Access Compliance Report

Public Rights-of-Way

Intersection ID: 30473	Main Street: BEDDINGFIELD_DR	Cross Street: PLANTERS_ROW_DR	Location: SW
ADA ID: 7440EB1D02C4	Ramp Type: PerpDiag	Initial Pass/Fail: Fail	Overall Compliance: No
Severity Score: 13.75			
Codes/Mitigation Info/Possible Solution		Field Measurements/Component Compliance

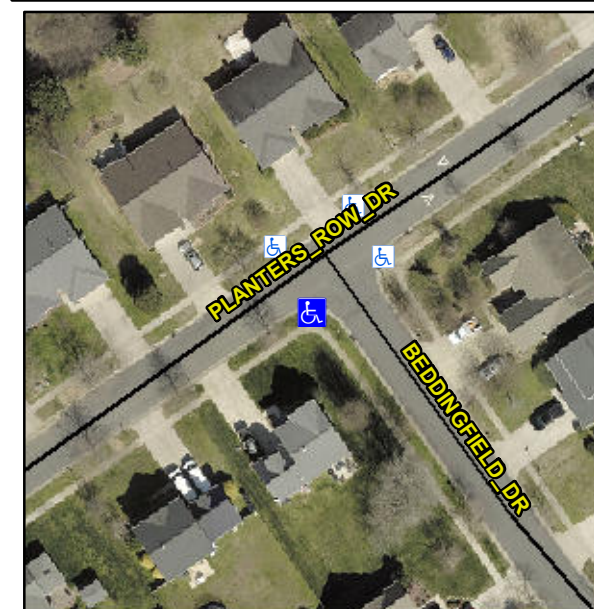
R304.2.2, R304.5.3

Compliance	Description	Data	Compliance	Description	Data
N/A	Ramp Length (in)	83.0	No	Ramp Slope (%)	8.9
Yes	Ramp Width (in)	48.0	No	Ramp XSlope (%)	2.1
N/A	Flare Type LT	N/A	N/A	Flare Type RT	N/A
N/A	Flare Slope LT (%)	N/A	N/A	Flare Slope RT (%)	N/A
N/A	Flare Traversable LT?	N/A	N/A	Flare Traversable RT?	N/A
N/A	Landing Length (in)	N/A	N/A	DWS Provided?	N/A
N/A	Landing Width (in)	N/A	N/A	DWS Contrast?	N/A
N/A	Landing Slope (%)	N/A	N/A	DWS Length (in)	N/A
N/A	Landing X Slope (%)	N/A	N/A	DWS Full Width?	N/A
N/A	Landing Curb? (Y/N)	N/A	N/A	DWS Offset (in)	N/A
N/A	Shared Landing?	N/A			
N/A	Gutter Ponding?	N/A	N/A	Gutter Slope (%)	N/A
N/A	Gutter Lip Ht (in)	N/A	N/A	Gutter X Slope (%)	N/A
N/A	Painted X Walk1?	No	N/A	Painted X Walk2?	No
	X Walk 1 Direction	To NE		X Walk 2 Direction	To NW
N/A	X Walk 1 Width (in)	N/A	N/A	X Walk 2 Width (in)	N/A
	X Walk 1 Slope (%)	0.4		X Walk 2 Slope (%)	2.5
	X Walk 1 X Slope (%)	0.3		X Walk 2 X Slope (%)	2.2

Remove & Replace Curb Ramp With Two New Directional Ramps or Equivalent.
